STATE OF MAINE
 DEPARTMENT OF TRANSPORTATION
 16 STATE HOUSE STATION
 AUGUSTA, MAINE 04333-0016

January 29, 2021
 Subject: International Bridge Rehabilitation
 State WIN: 021736.00
 Location: **Madawaska &
 Edmundston, Canada**
Amendment No. 3

Filename: 087_Girder Details 3 - General Details.dwg

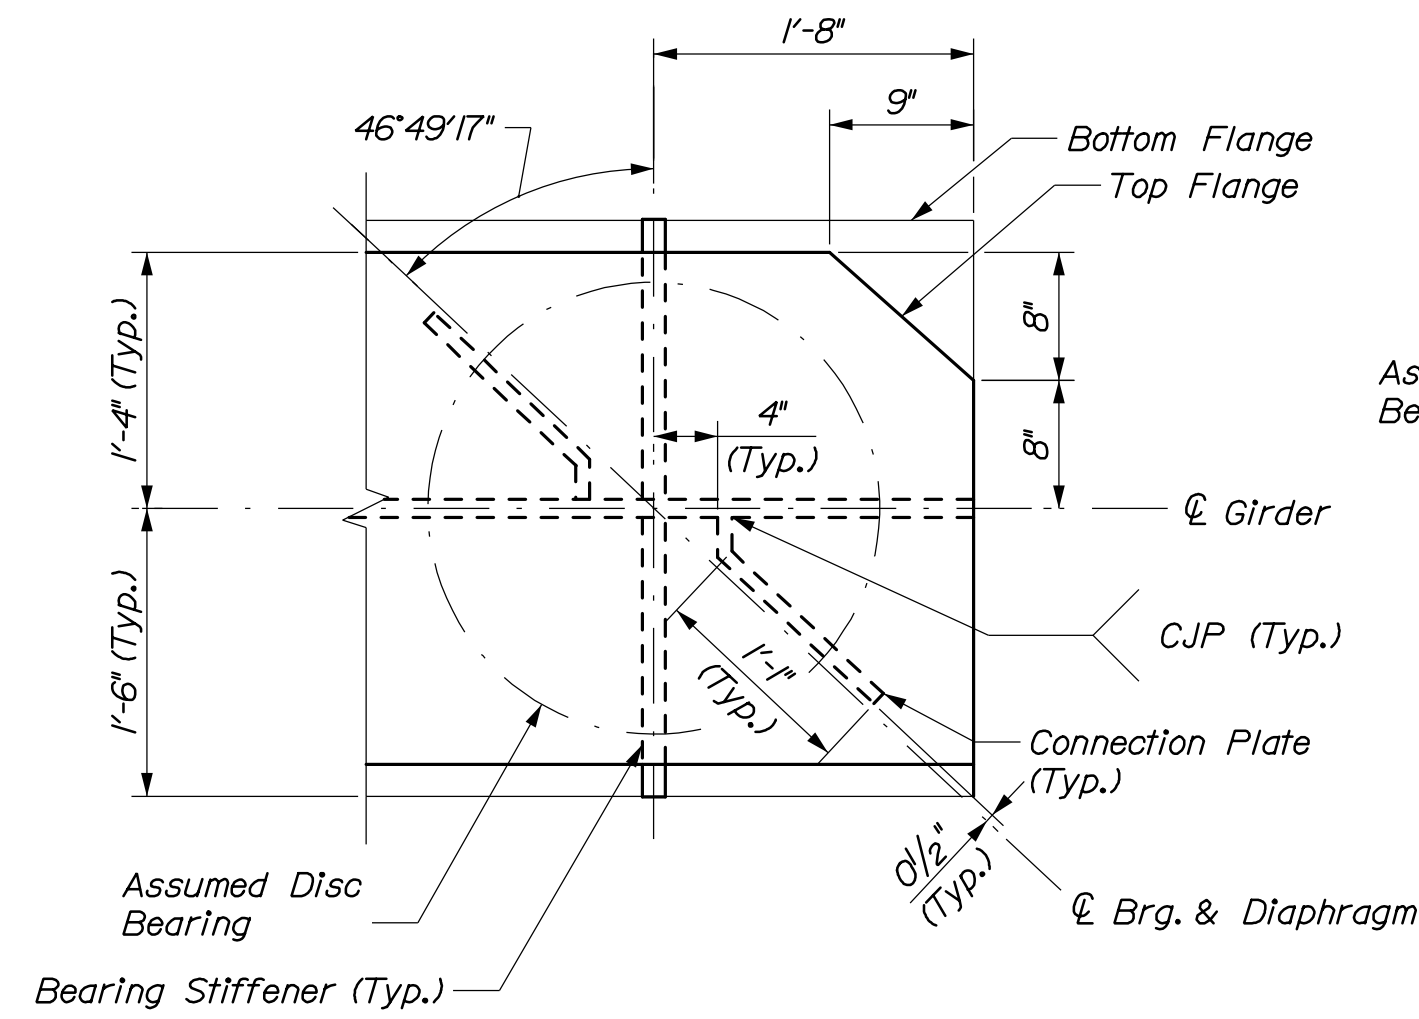
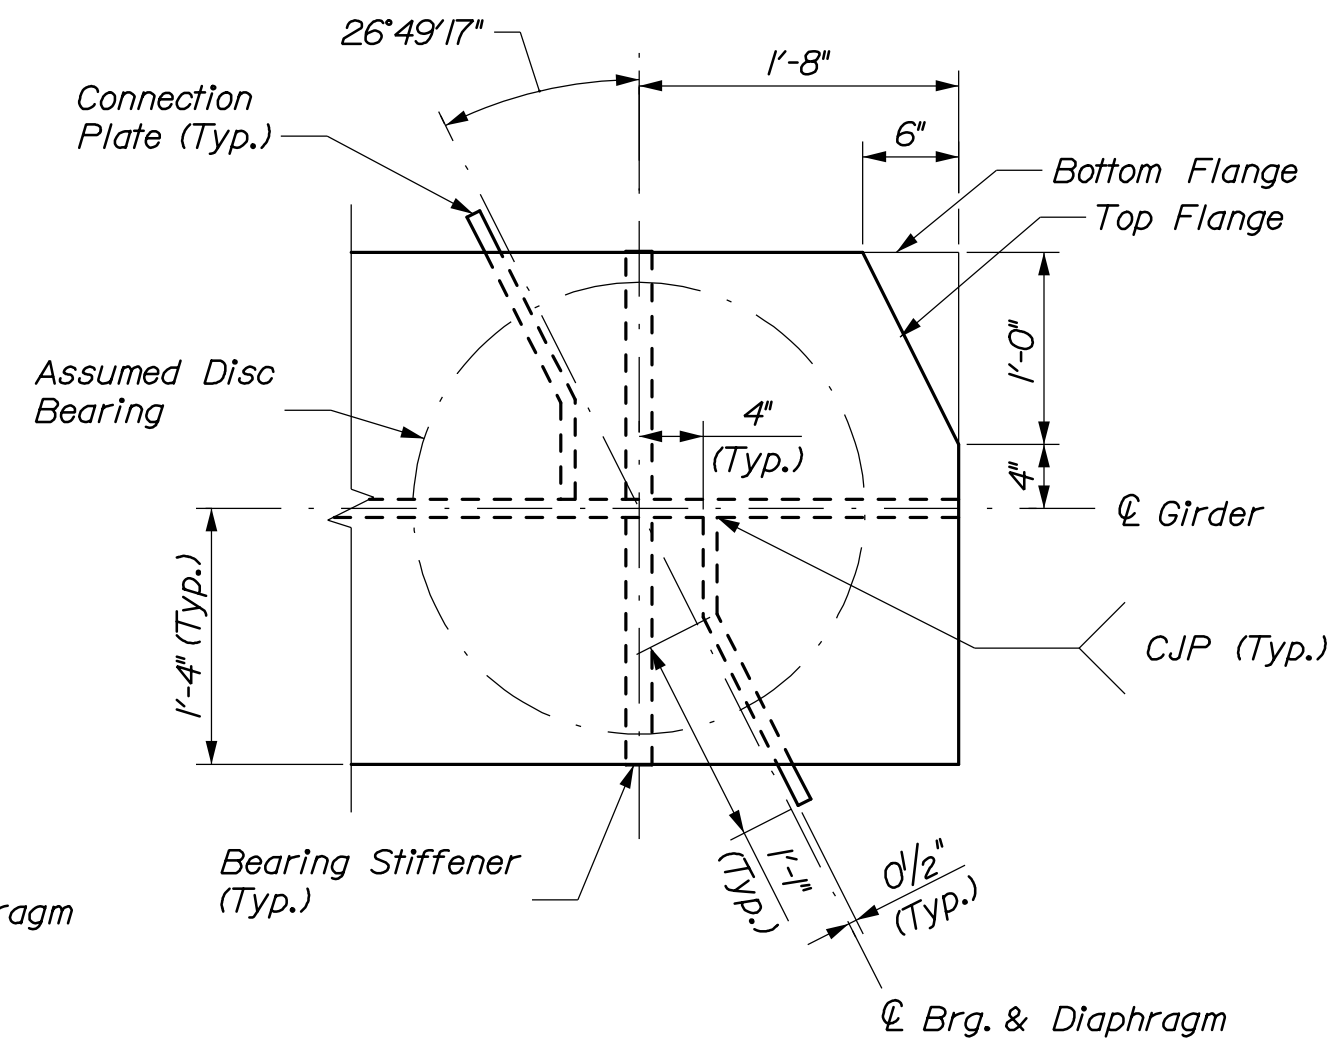
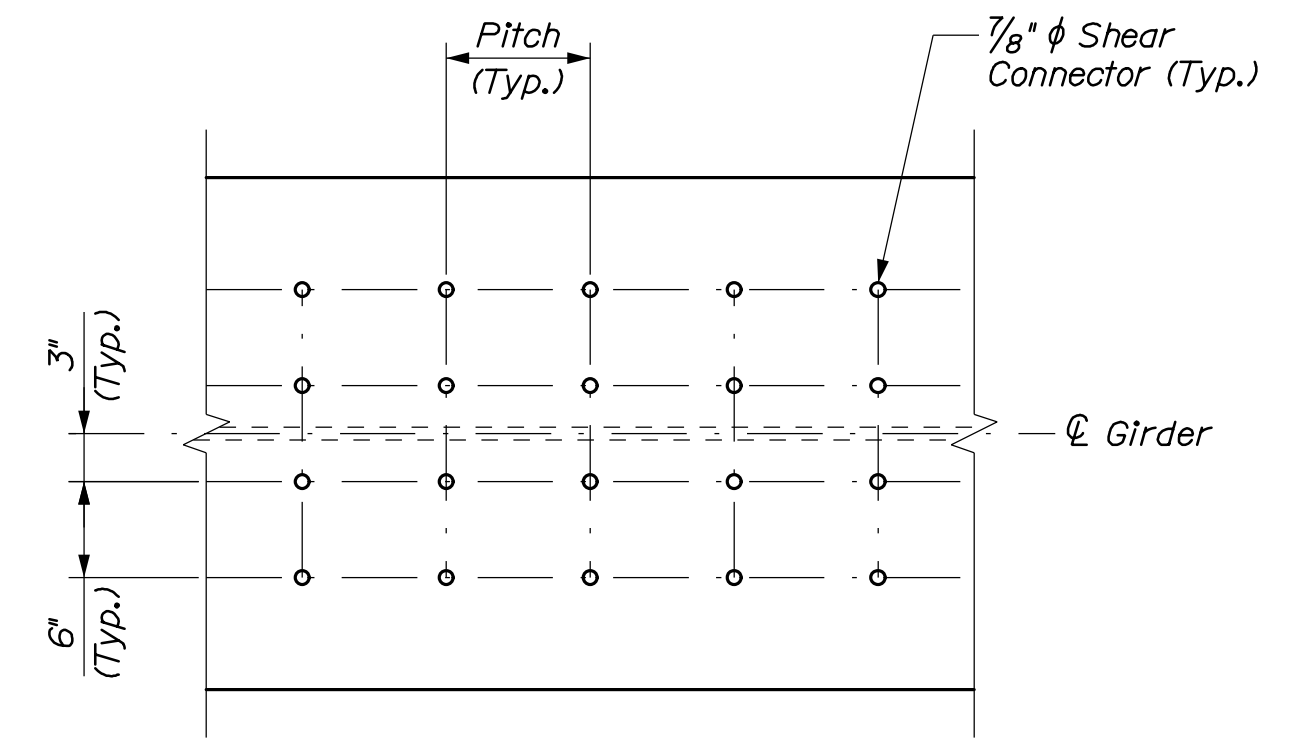
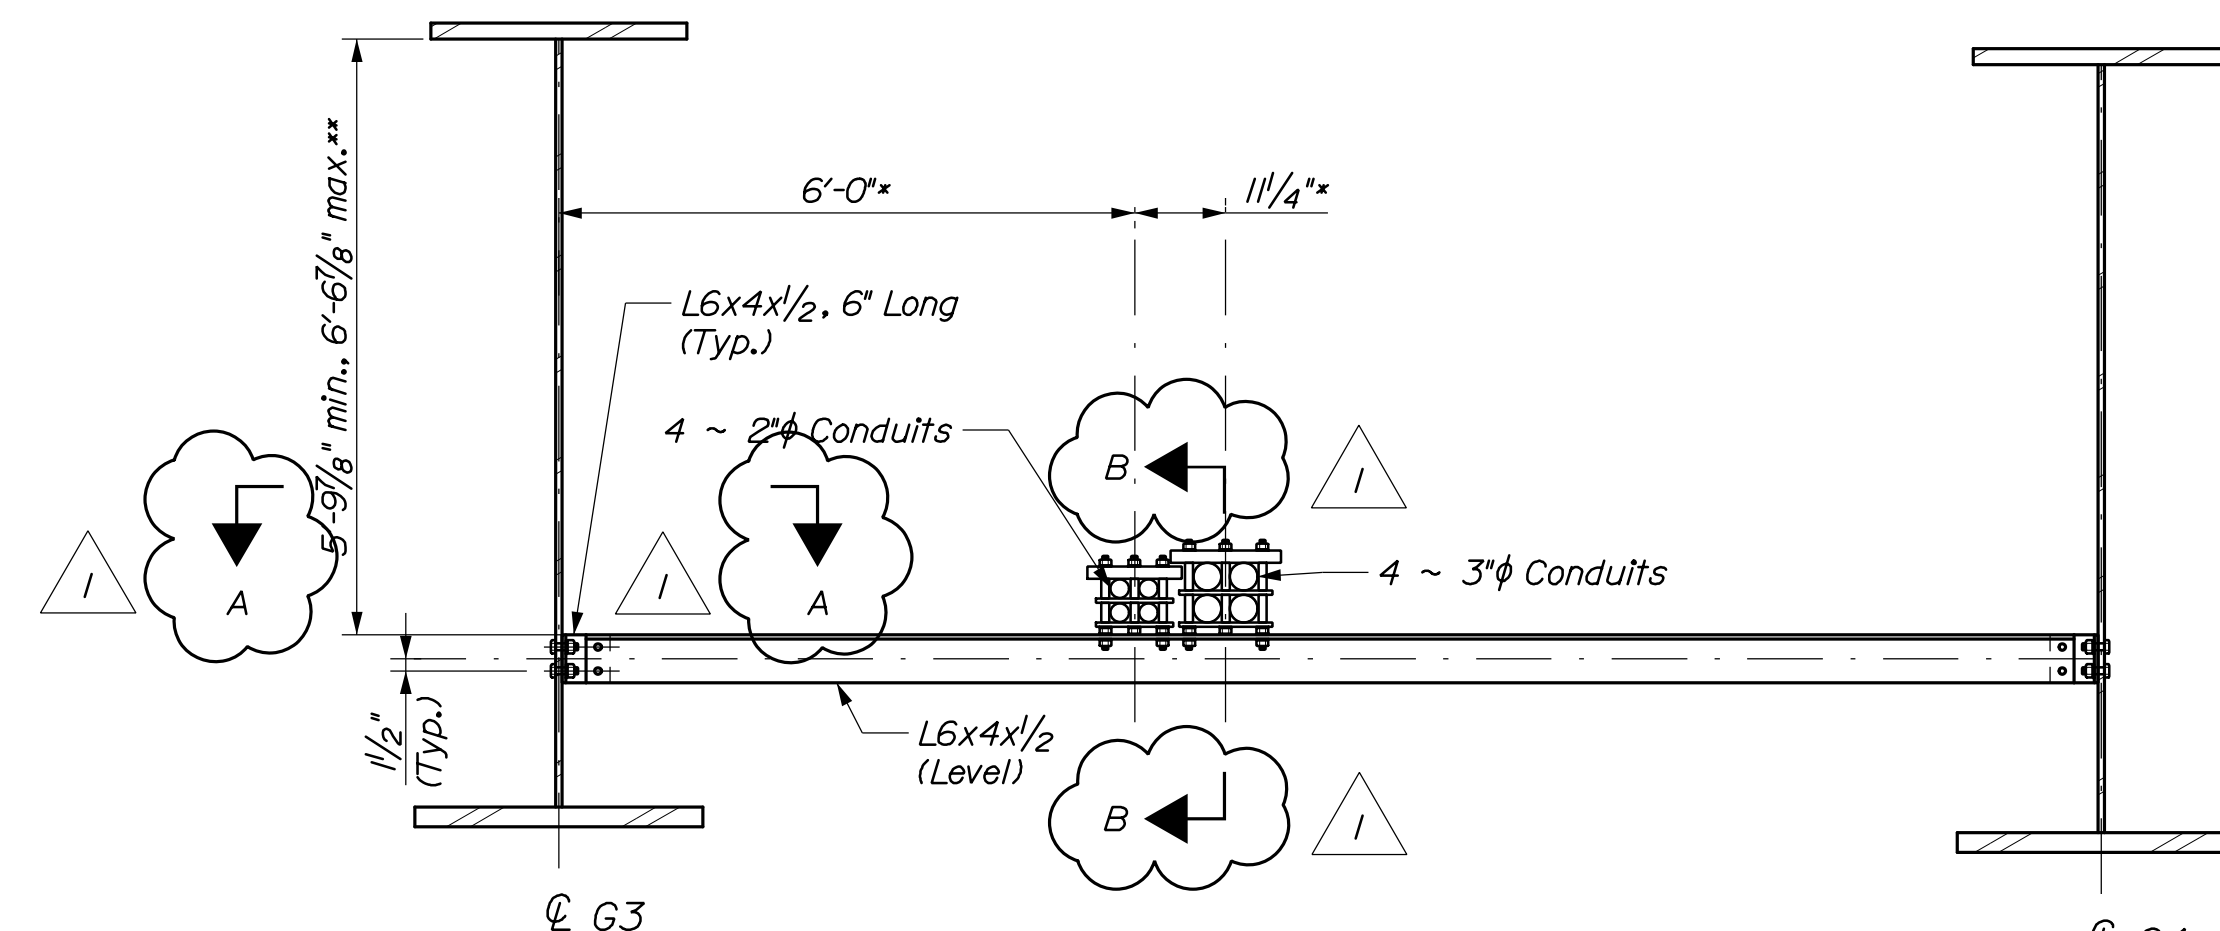
Question: (dwg 87) Utility conduits (2 – 4” FRE conduits) are to be installed between G2 & G3. Plans do not appear to show additional utility support angles between these girders. Canadian Electrical Code requires maximum 3m between support spacing. Please confirm support spacing in this area.

Question: (dwg 87) Will utility support members be pre-drilled for installation of conduit hangers?

Response: The two noted conduits, located between girders G2 and G3, are to be removed from this contract in their entirety. This includes underground portions of these conduits, associated utility blockouts within the abutment backwalls, conduit supports connected to the cross frames, and estimated quantities. Revised Plan Sheets are provided with this amendment.

Response: Holes in the girder webs and utility support members shall be pre-drilled to accept the Contractor’s selected utility conduit and hanger system. The necessary hole sizes and spacing shall be shown on the Structural Steel Girder Shop Drawings for review. This is a coordination item between the Contractor, their conduit vendor, and steel fabricator prior to submitting Shop Drawings.
